Accufacts Inc.

An Independent Analysis of the Proposed Brunswick Pipeline Routes in Saint John, New Brunswick

**By
Richard B. Kuprewicz
President, Accufacts Inc.
kuprewicz@comcast.net
September 16, 2006**

Figure 1: Applicant's Proposed Saint John On-land Route with Marine Option Routes Added

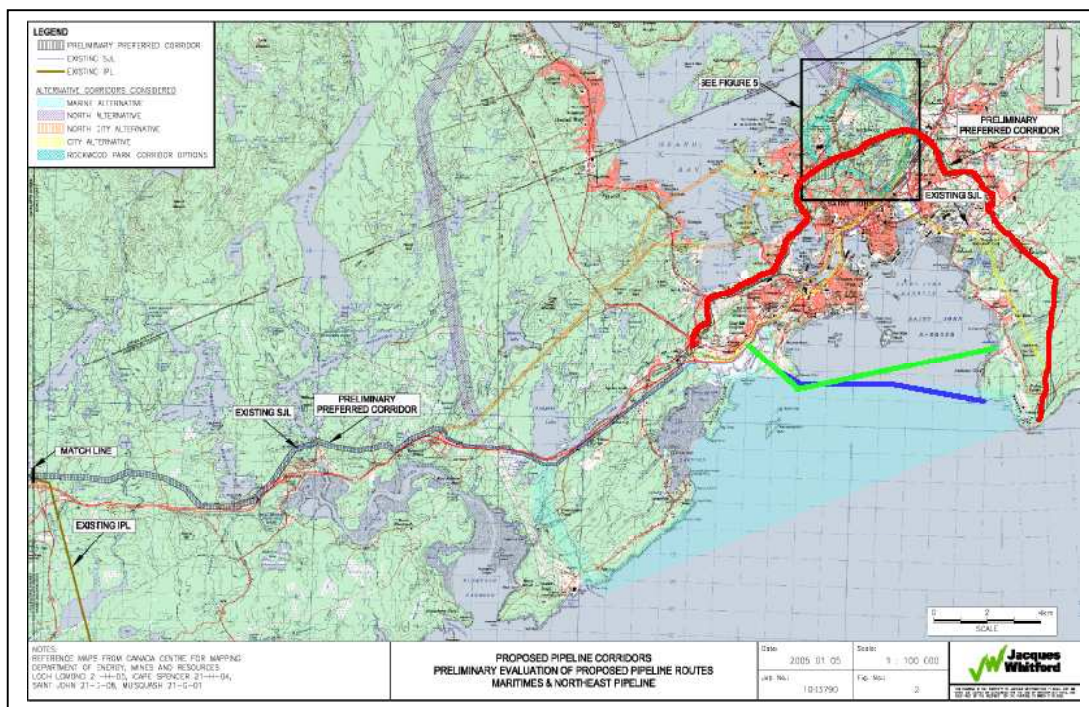
while the heavier red highlight line represents the general on-land route through the city proposed in the Application.¹⁴ Note that in either of the marine options indicated in Figure 1, the suggested crossing should pass north and stay out of the “Anchorage Area A Zone” located further out in the harbour. The routes indicated in Figure 1 are also approximate as actual routes could change slightly pending further review/evaluation.

Figure 1 indicates an on-land route option (heavier red highlighting by Accufacts and black cross hatch labeled by the pipeline as the “Preliminary Preferred Corridor”), proposed in the Application that takes the pipeline through the city of Saint John. The Application indicates that most of the pipeline route has been chosen to utilize existing or planned utility rights-of-way, but the corridors utilized within the city are not clearly indicated or identified in the Application. For the purposes of this study, Accufacts Inc., in order to maintain our neutrality, will call this option though the city the “on-land” route option. In evaluating the wisdom of certain pipeline routes, specific attention should be paid to the population density (both building and especially potential unsheltered individuals), and possible escape routes that can be hindered or restricted by the terrain, as well as sensitive facilities or industries in proximity to a transmission pipeline route. Utility corridors are seldom of sufficient width to provide adequate protection for the controlling pipeline safety case, a pipeline rupture. Few countries have proximity regulations defining minimum offset distances that a gas transmission pipeline must be from sensitive receptors that might be impacted in the event of a pipeline failure (either a leak or rupture). Neither the Canadian nor U.S. gas transmission pipeline regulations, standards, or codes define or require transmission pipeline safety offset distances.

Figure 3: Aerial View of Saint John Approximate On-land Pipeline Route (yellow), with Illustrated 600 meter (20 KW/m²) PIZ Radius (red)

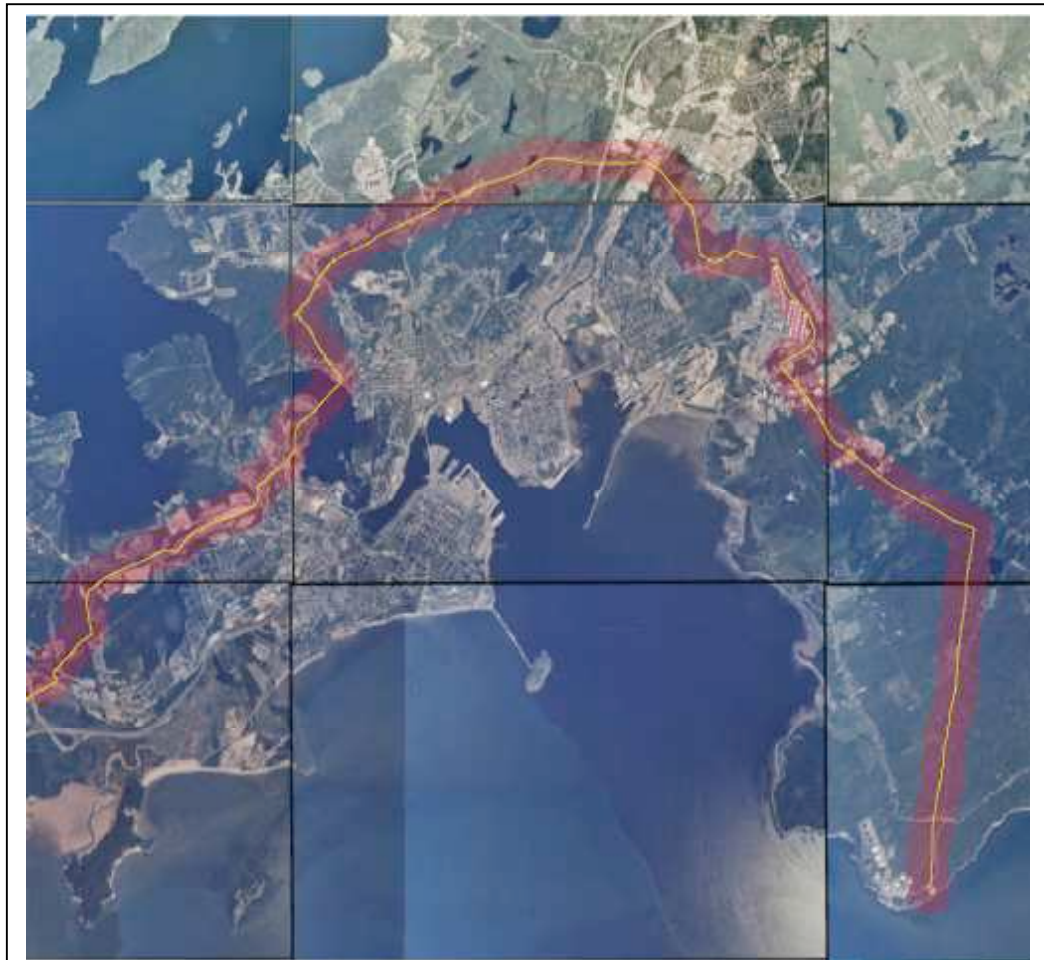
In Figure 3 the PIZ for the estimated on-land route have been highlighted (pipeline location approximated in yellow and subsequent potential impact zones in opaque red) to provide a quick appreciation of the possible receptors in the pipeline’s potential impact zone. Note that the exact location of the on-land pipeline has not yet been established so there can be a wide variation in the location as well as the boundary of the impact zones. **The highlighted zone in Figure 3 is provided for illustration purposes only** and is based on the Application’s QRA provided distance values for 20 KW/m² in the event of a pipeline rupture (approximately 600 meters on each side of the pipeline, see Table 2 later in this report). As presented in further detail in the next section discussing ruptures, 20 KW/m² thermal flux is still quite high. Lower acceptable thermal flux values are warranted and such lower thermal values define larger potential impact zones. One of the key questions in addressing the on-land route option is what is the acceptable thermal flux for this route?

Figure 3 clearly suggests that there is considerable sensitive receptor and infrastructure at risk along the rupture potential impact zone along the on-land route through the city of Saint John.

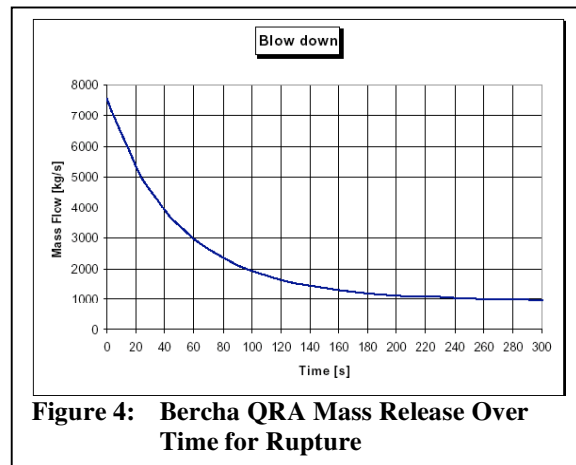
Figure 4 is taken from the Quantitative Risk Analysis submitted with the Application for the Brunswick Pipeline.²⁹ This figure is intended to represent a blowdown (mass release vs time) for a pipeline rupture in the urban segment defined in the report as BP1-R (the rupture blow down for the segment between Kp 0 to 11.0). The QRA states “There is very little difference among the 5 minute blowdown characteristics (and therefore consequences) of failure of different segments, because, until the

isolation valves are closed (which is 15 minutes or more), the entire pipeline is being emptied through the failed orifice.”³⁰ Accufacts agrees with this statement, but we believe the critical factor for a rupture is time to ignition as early ignition generates the greatest heat flux and largest thermal impact zone most injurious or fatal to the public.

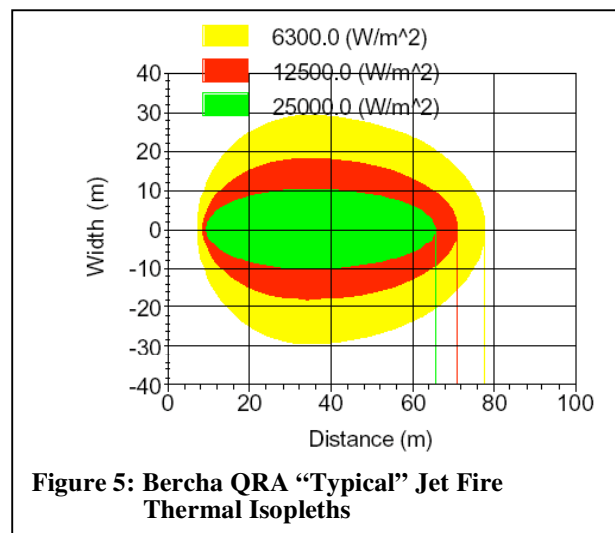
Figure 5 is also taken from the submitted QRA.³¹ In comparing this “Typical” Jet Fire Thermal Isopleths (boundaries of constant heat flux), against Table 2, developed from information provided in the Bercha QRA, it appears that the QRA “Typical” Jet Fire Thermal Isopleths seriously confuse, misrepresent, and understate the thermal impact zones associated with a rupture (all ruptures upon ignition are a jet fire).³² While Figure 5 may be intended to convey the impression that a typical rupture impact zone is small,
